# SITE PLAN/PRELIMINARY PLAT/FINAL PLAT FACT SHEET

Applicant:	D. C. Venture			
Name of Propo	osed Development:	Oak Creek		
Acreage: 17	.861			
Number of Lot	.s: 78	_		و
Current Zonin	ıg:2-F		<u>*</u>	
Surrounding Z	Coning: LI		_	
		i		
Description:	Duplex development on Each half of a duple:	n SH-66 just east of x would be sold with	Middle School. its own lot.

## OAK CREEK

RE: Oak Creek ROK 84815

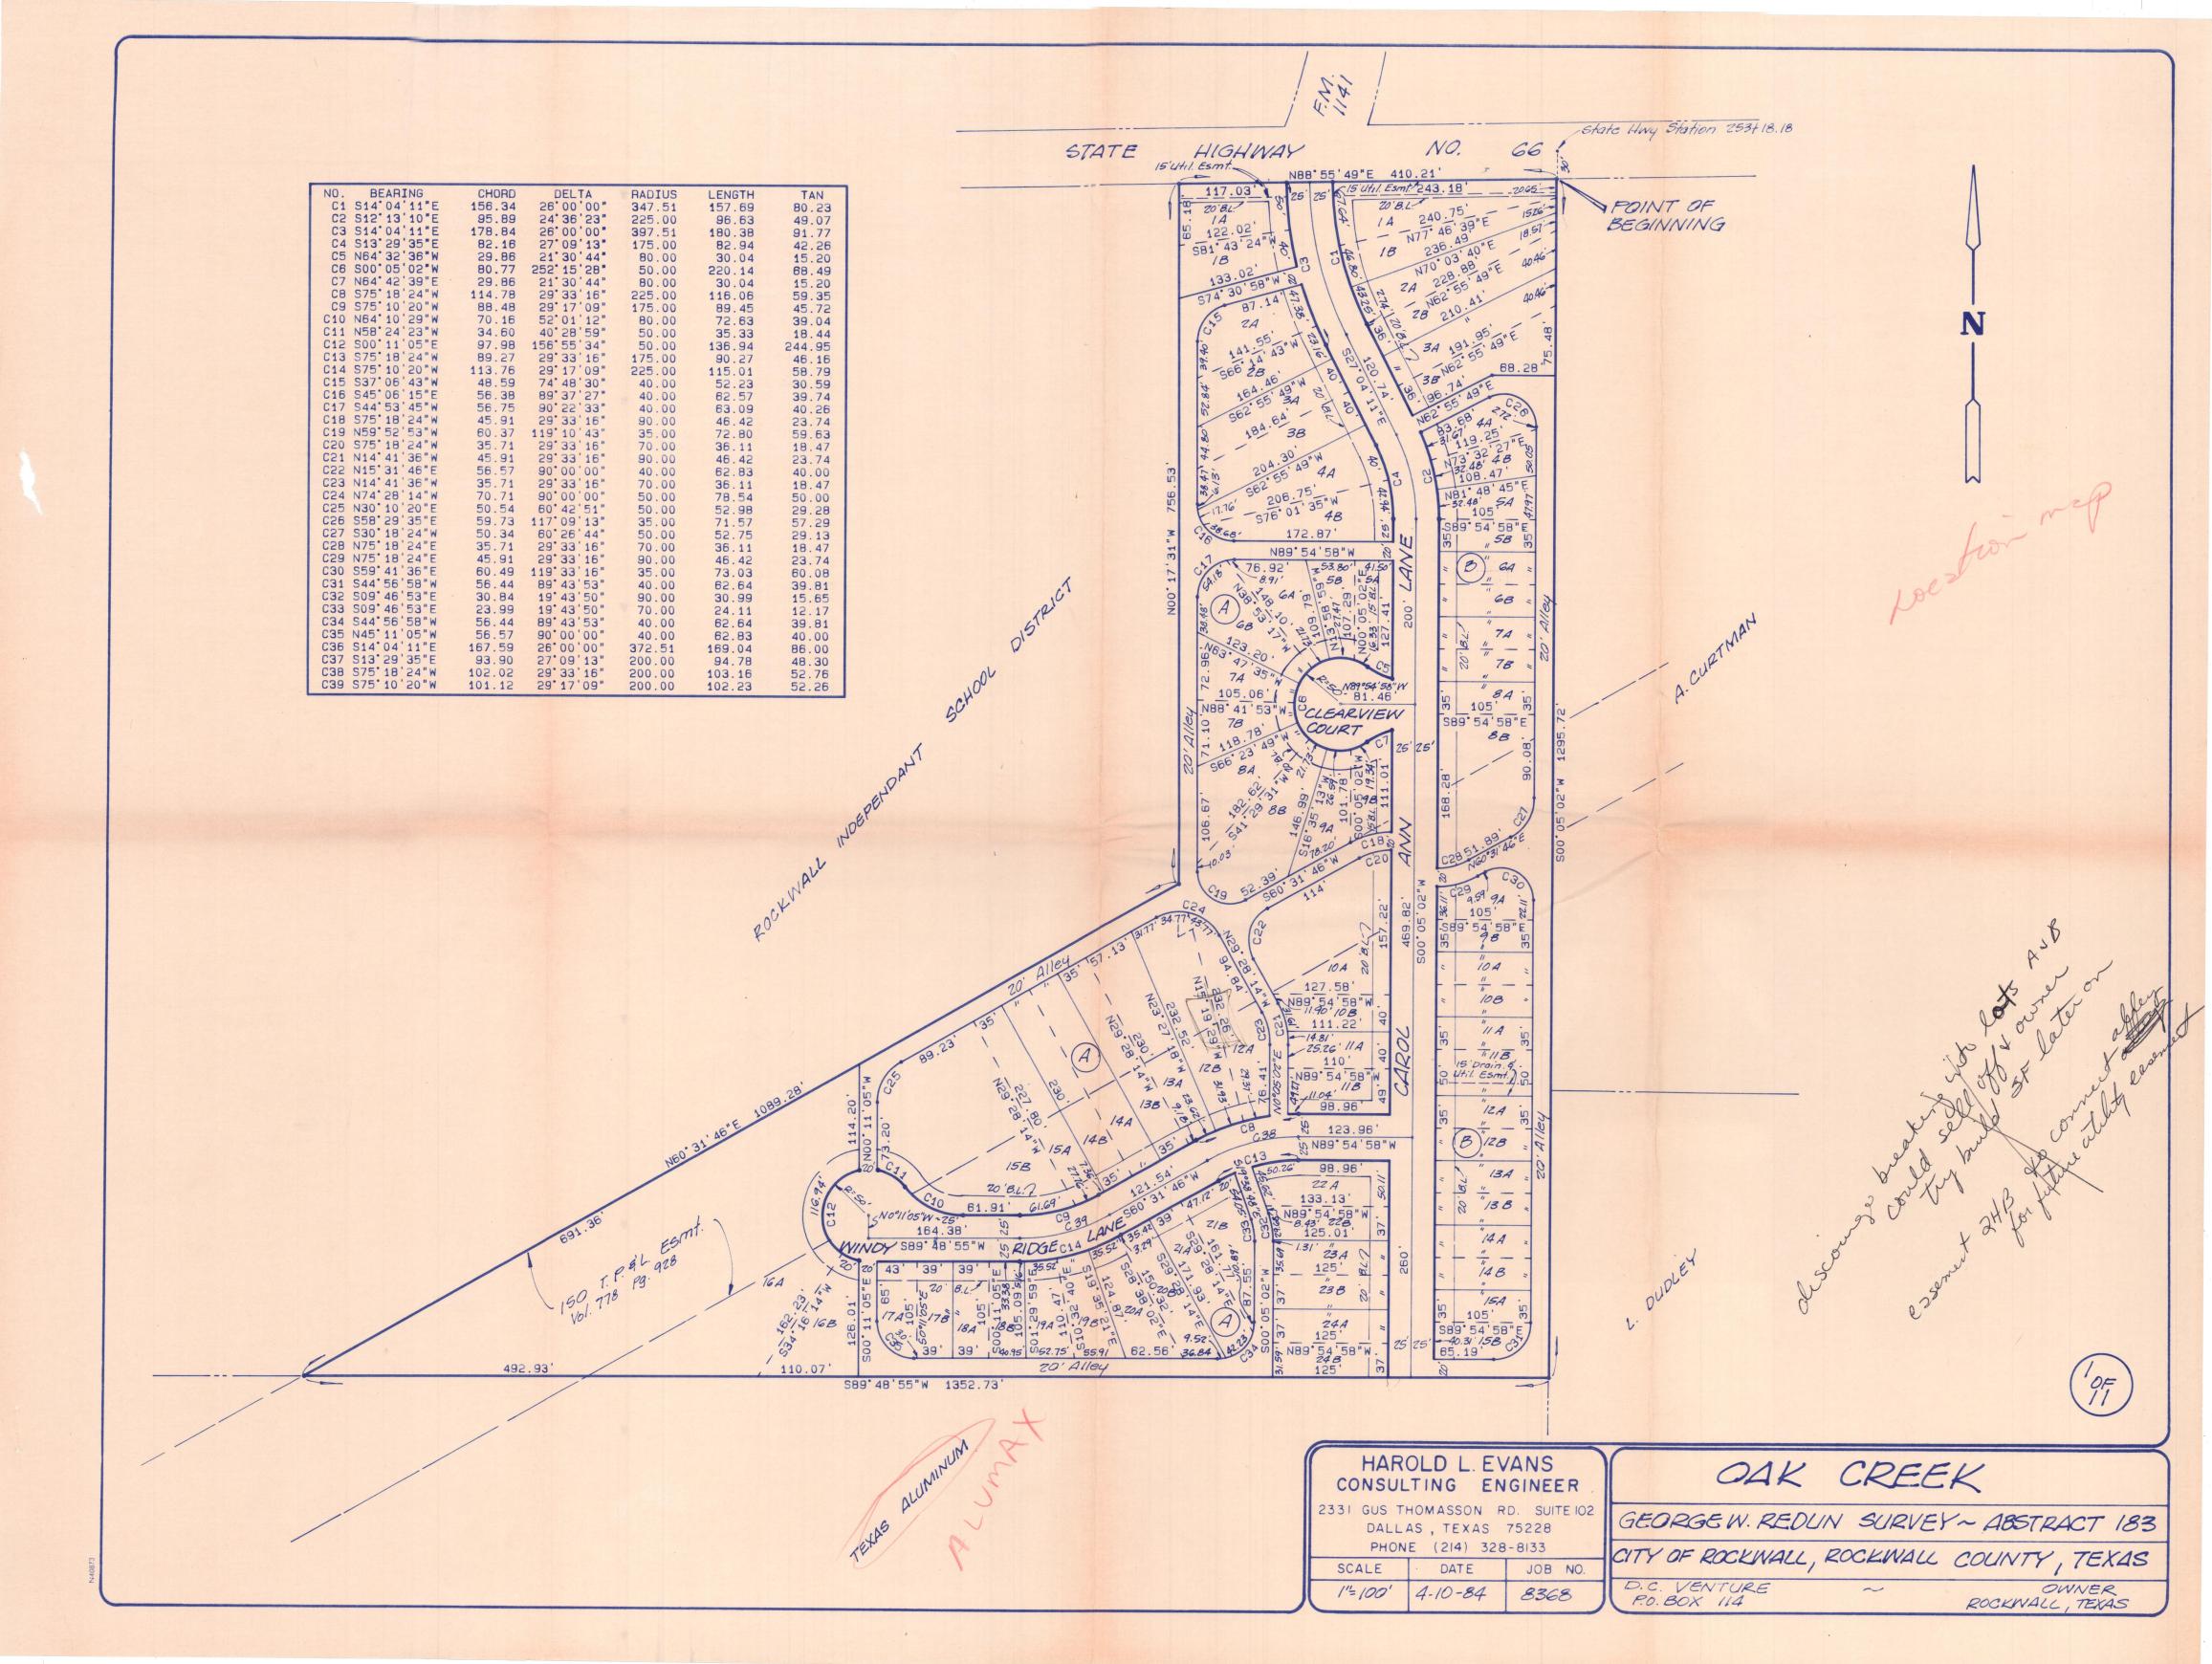
- 1. Location map
- 2. Check if Alumax or RISD owns adjoining property.
- 3. Change name of Windy Ridge Lane
- 4. Access easement along rear of Lot 1B, Block A
- 5. Restrict plat to designate which lots are combined for one duplex
- 6. Split into more blocks
- 7. Oversize water line needed
- 8. Need 60 ft. ROW or easement

5/10/84 - Approval with street name change, lots designated for duplexes, subject to engineering, and no collector. If thoroughfare plan shows collector then rezone to "LI".

6/4/84 - Approve subject to engineering with no Certificate of Occupancy granted until sewer repair complete or June, 1985, whichever comes first.

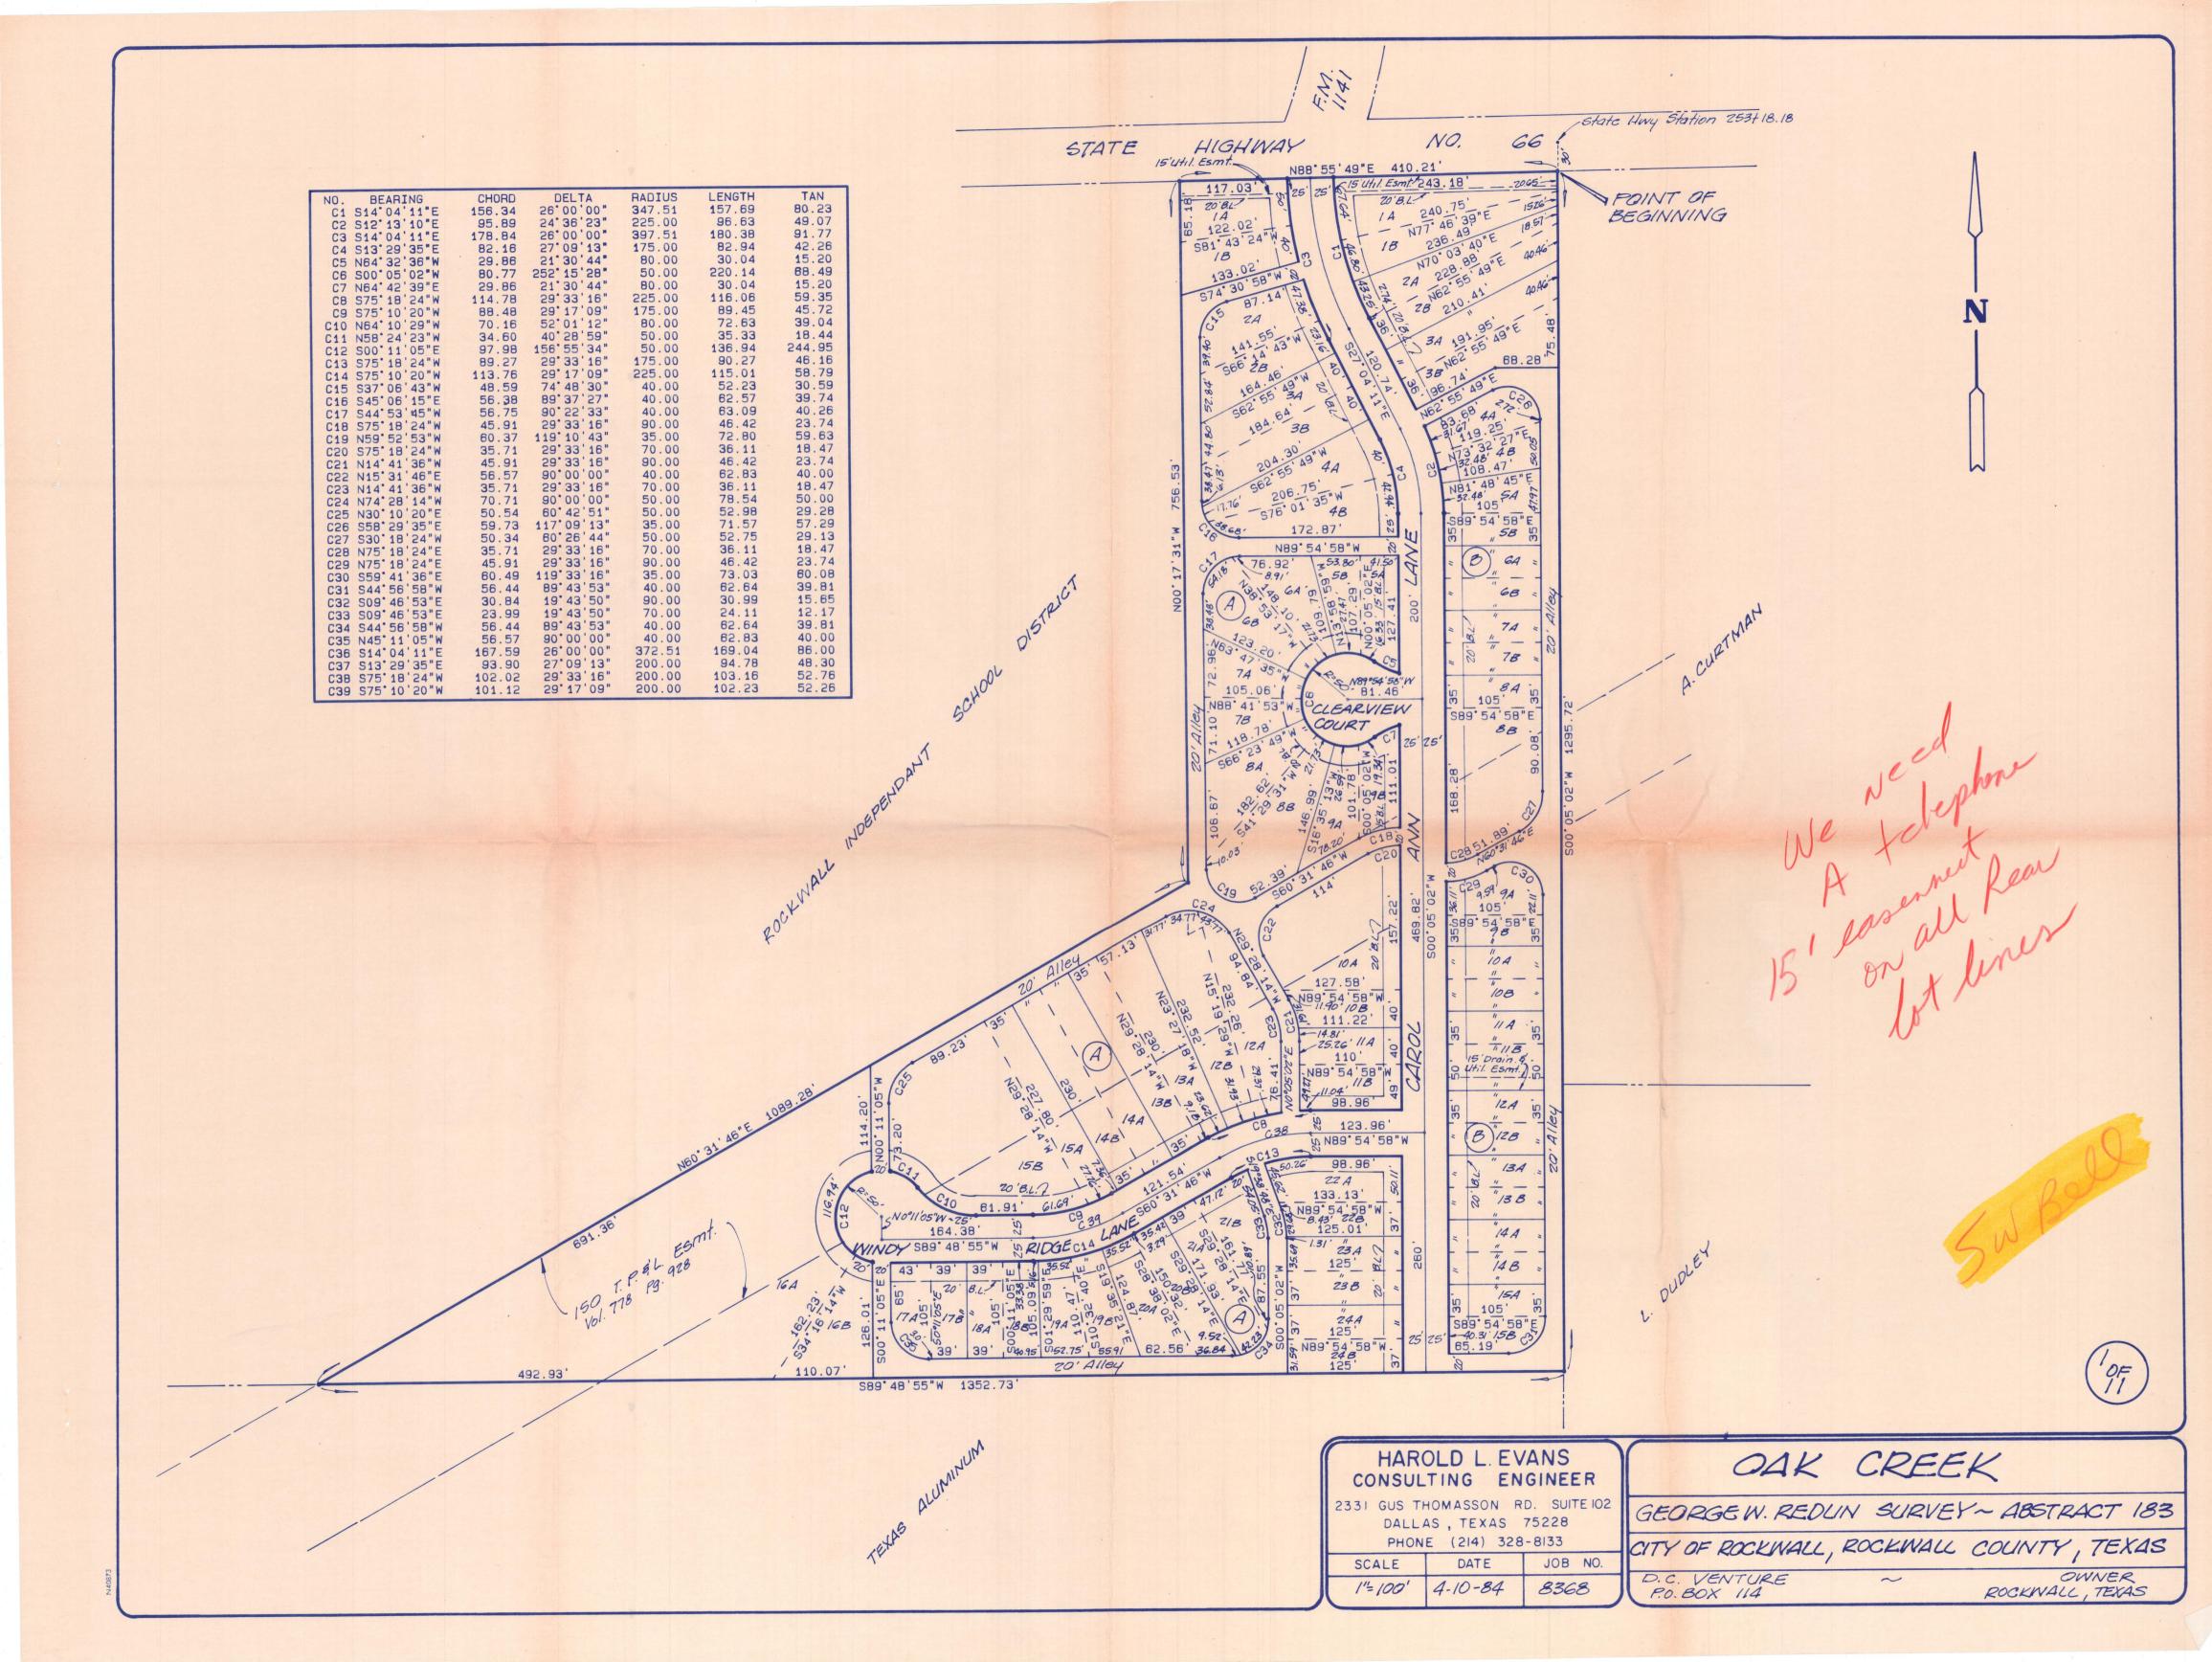
- 1. It is recommended that a vicinity or location map be provided on the file plat drawing.
- 2. It is recommended that utility easements be provided along perimeter boundaries for future development.

- 3. The T. P. & L. easement is shown at different widths on the plat. It is recommended that the easement be indicated so that the location of the width change be shown.

- 4. The manner in which the lots are shown implies that portions of a lot could be purchased separate from the original lot. By subdividing lots into A and B, these subdivisions actually serve as legal descriptions and each A or B represents one lot. This actually makes the typical lot size approximately 35' x 105' or 3,675 sq.ft. According to the zoning ordinance, the minimum duplex (2-F) lot size is 7,000 sq. ft. with a 60' front. Therefore, it is recommended that the designation of A and B be omitted and the front dimensions be indicated as one dimension whenever possible.

- 1. The Rockwall Standards for Design requires a temporary turnaround for streets that dead-end and are not a cul-de-sac. This would require a temporary easement for that portion that is located outside of street right-of-way. It is recommended that Carol Ann Lane comply with this requirement.
- 2. It is suggested that valley gutters and storm water flow direction arrows be indicated on the paving plans.
- 3. It is recommended that all underground utilities crossing the streets be shown in the profile in order to determine their relationship with the paving.
- 4. The paving sections in the details need to reflect Type "H" and Type "C" paving sections as per the City of Rockwall Standards for Design.

- 1. The plans indicate that at the intersection of Carol Ann Lane and Hwy. 66 the storm water falls off the edge of paving into the ditch. This suggests a potential erosion to ditch and subgrade. It is recommended that a design addressing this be indicated on the plans.
- 2. It appears that the drainage data table on the Drainage Area Map has some discripencies. The areas of 3, 4 and 5 appear to be in error and the accumulative quantities for 1 through 4 are in error
- 3. It is recommended that the ditch located in the rear lots of 1A through 6B of Block B be improved in accordance with the Standards for Design of the City of Rockwall.

1. The plans indicate 6-inch water lines to be located within the addition. Even though this system ties into a 6-inch main, the Rockwall Standards for Design state that any dead-end water line with two or more fire hydrants shall be at least a 8-inch line. Therefore we recommend that the 6-inch line shown in Carol Ann Lane and the 6-inch line in Hwy. 66 be changed to at least an 8-inch line.

2. The City of Rockwall's long range water plan indicates an 18-inch water main located along Hwy. 66 and a 12-inch main extending south along this property. It is suggested that the City consider installation of these main lines at this time.

1. Line "A" indicates a manhole located at Station 0+00. The drop in this manhole exceeds 24-inches. The State Health Department requires a drop manhole at locations where the drop to invert exceeds 24-inches.
